Turkey Creek Regional Sewer District Raw Water Supply Well

ADDENDUM 2

October 20, 2026

E-1.1

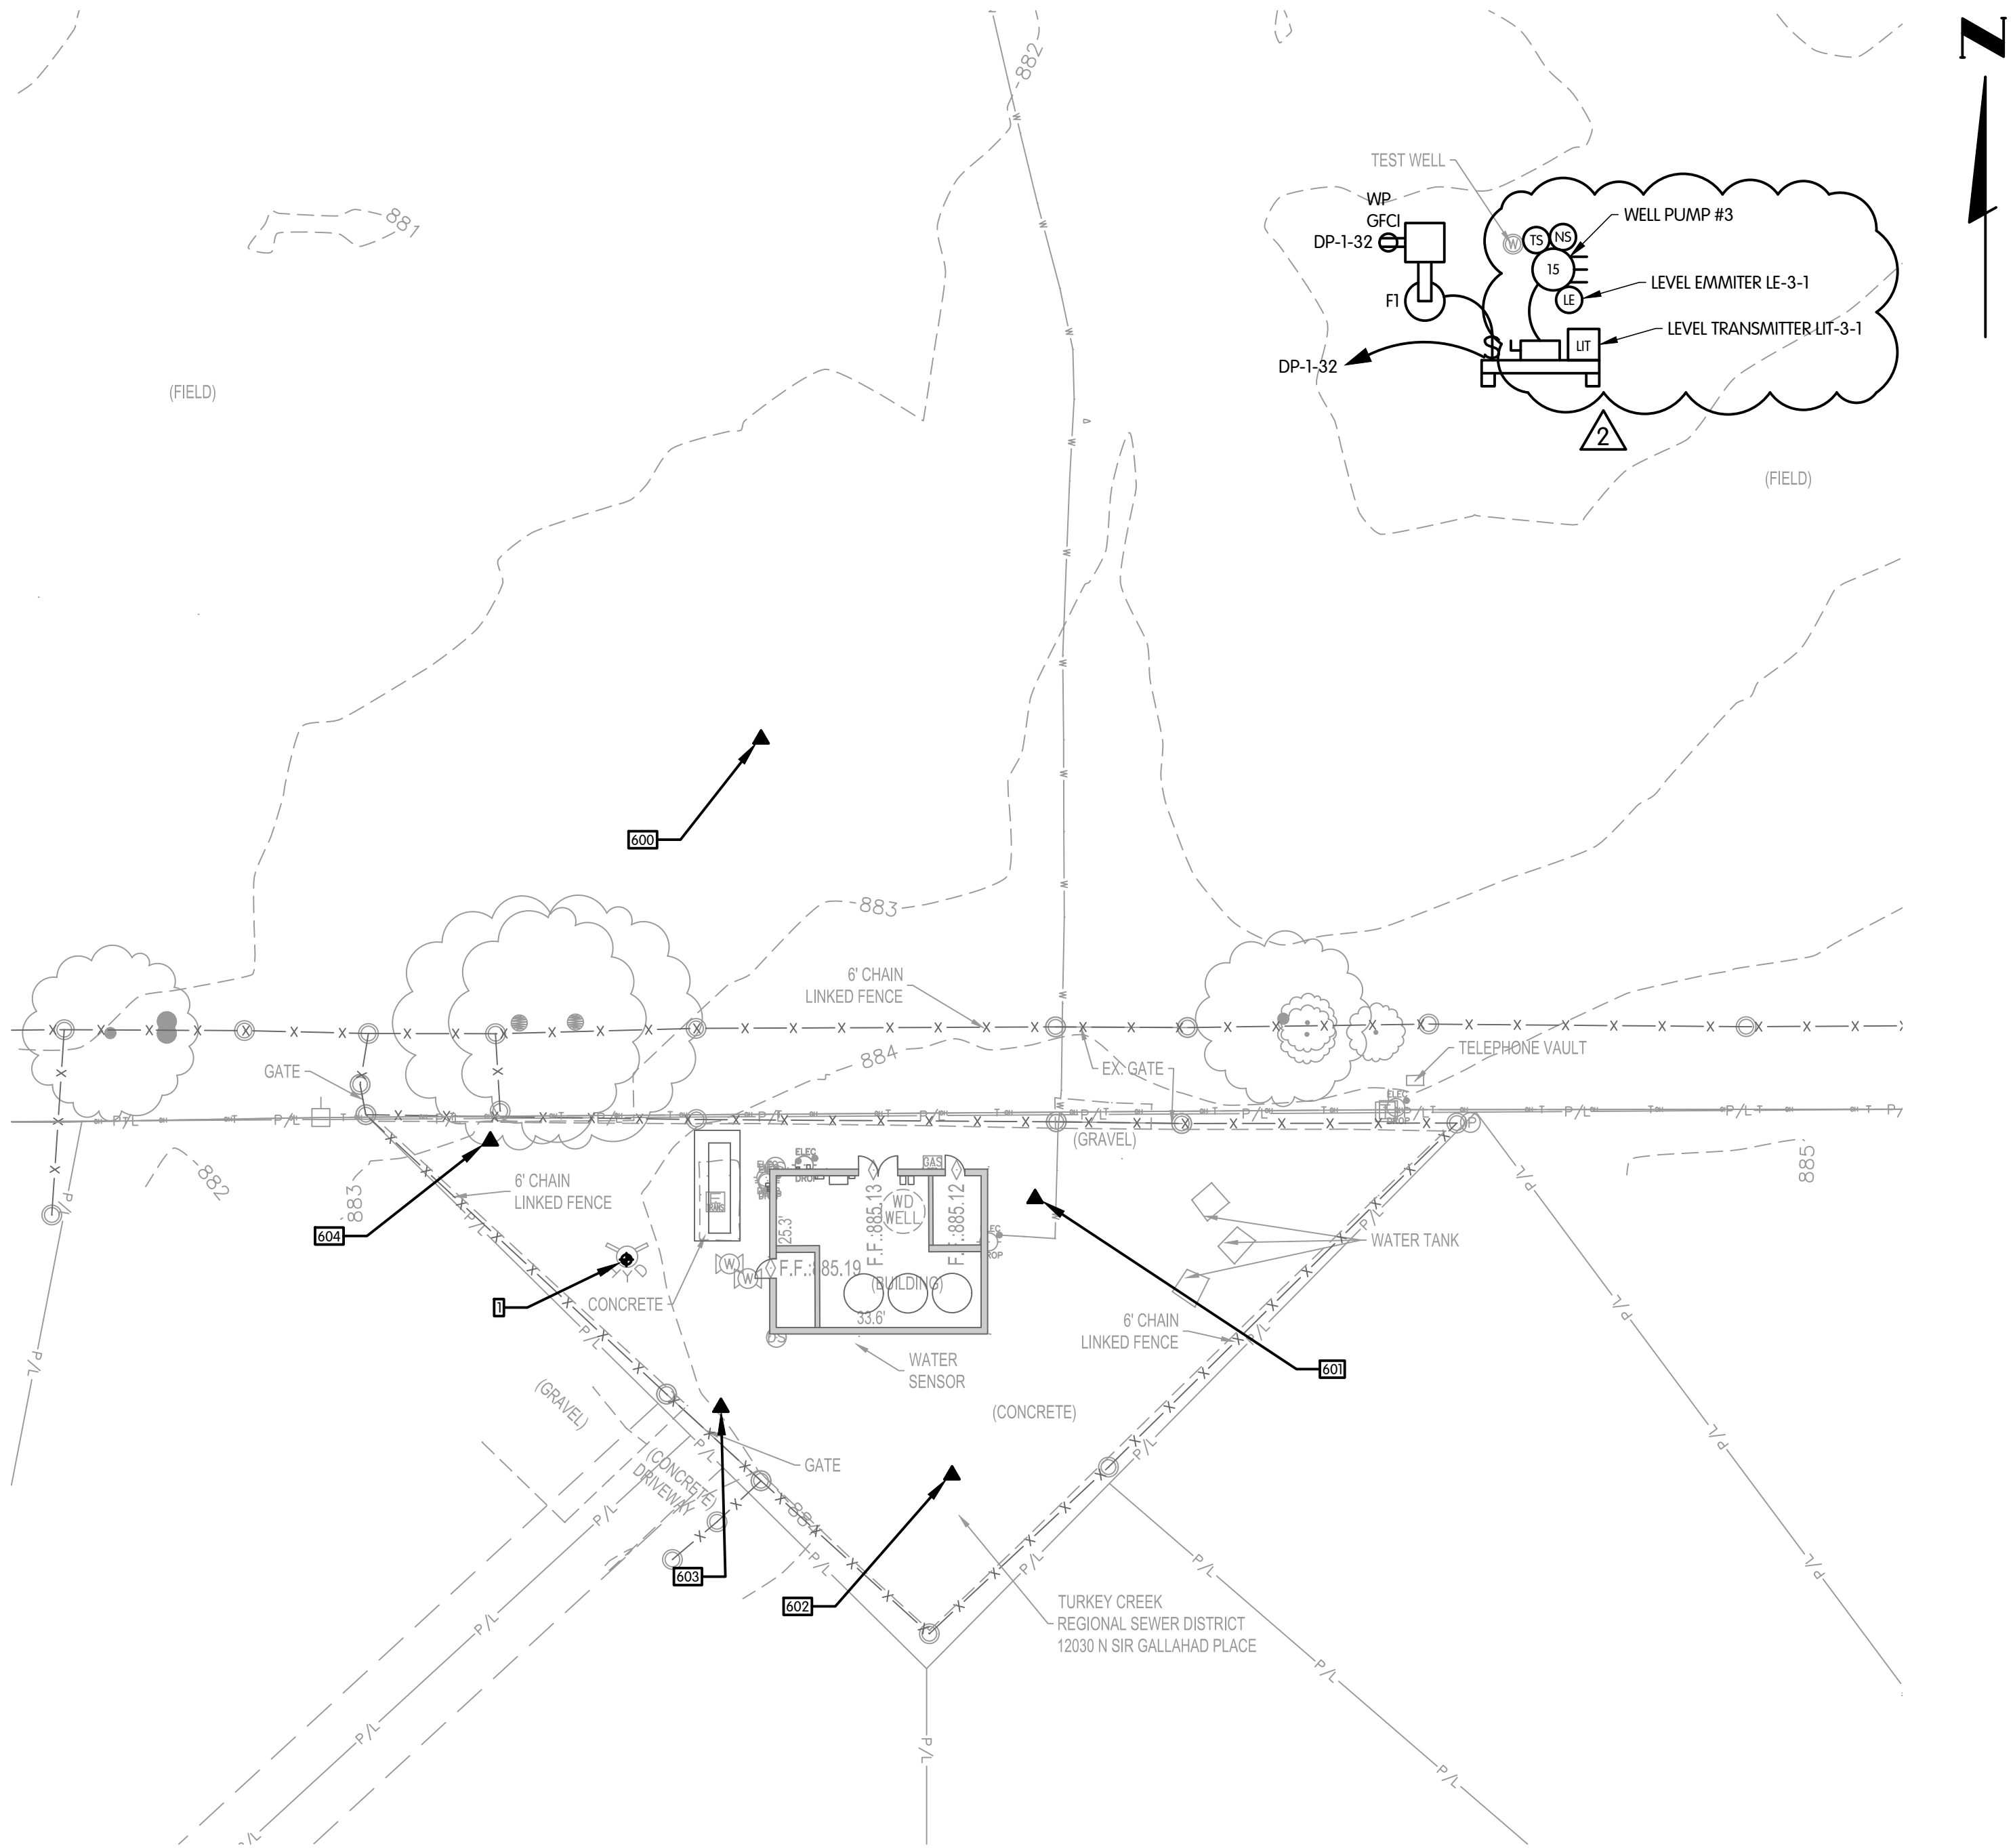
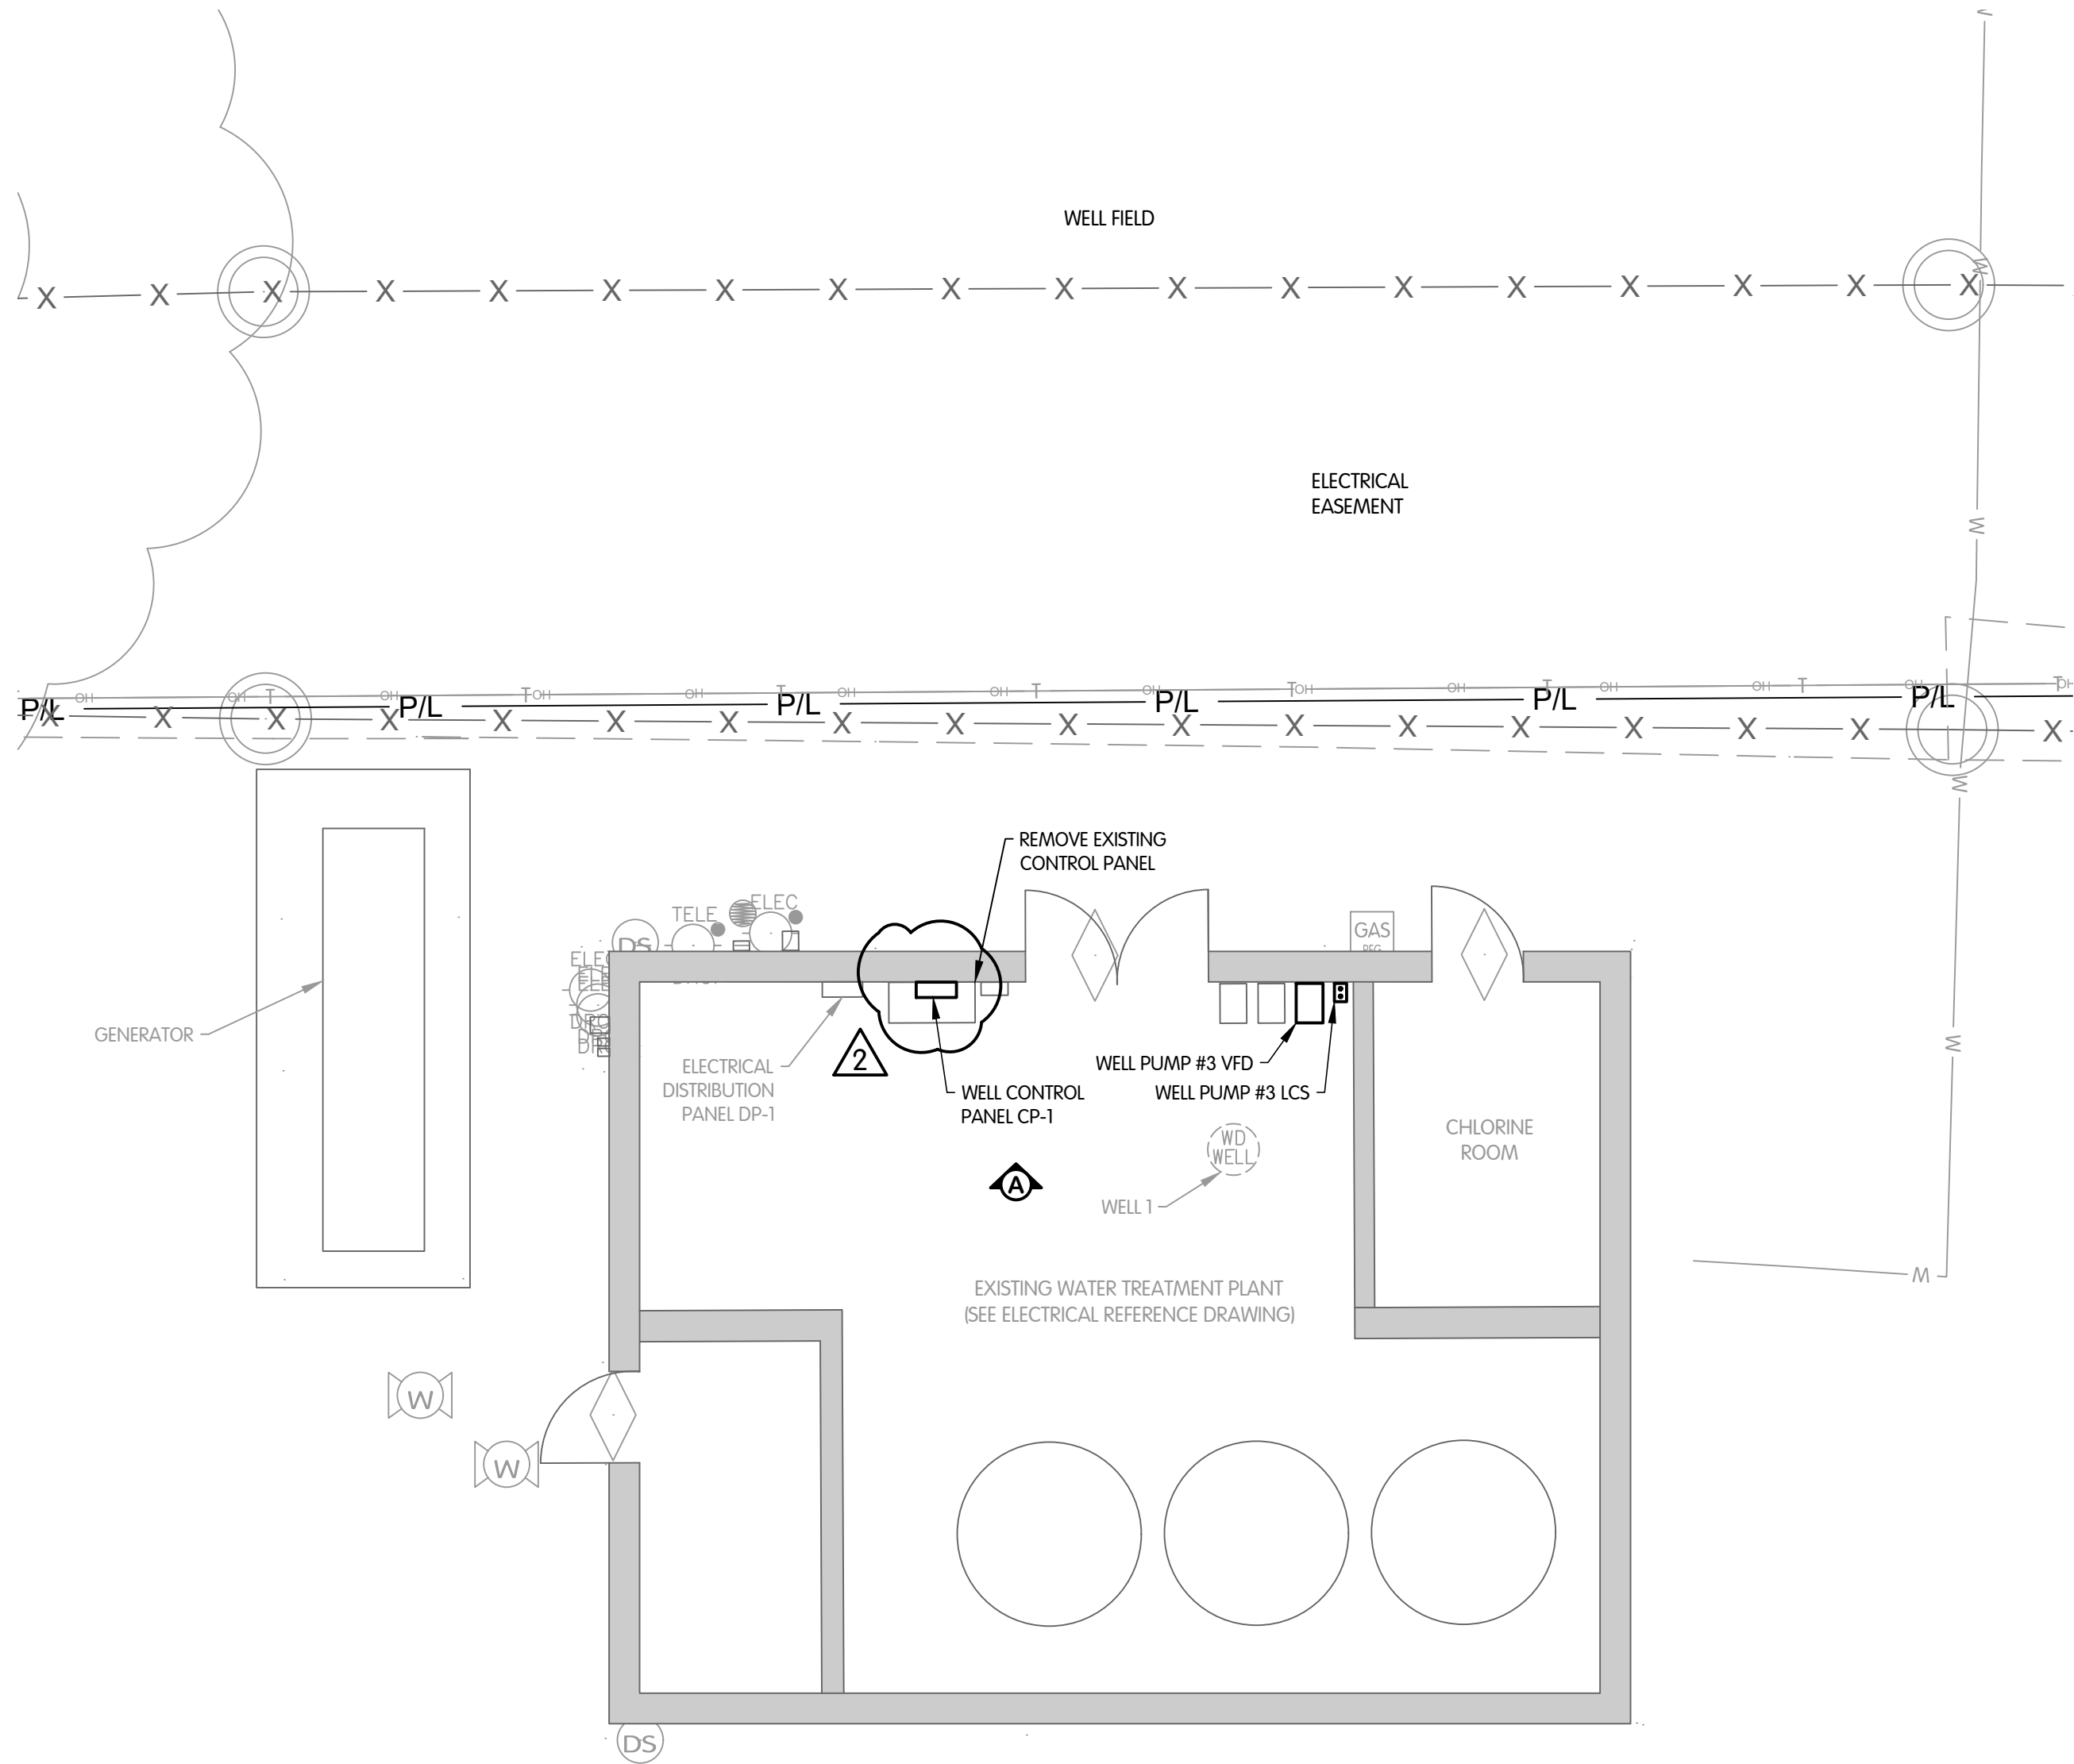
Sheets E-1.1: Delete and replace sheet, add control panel location.
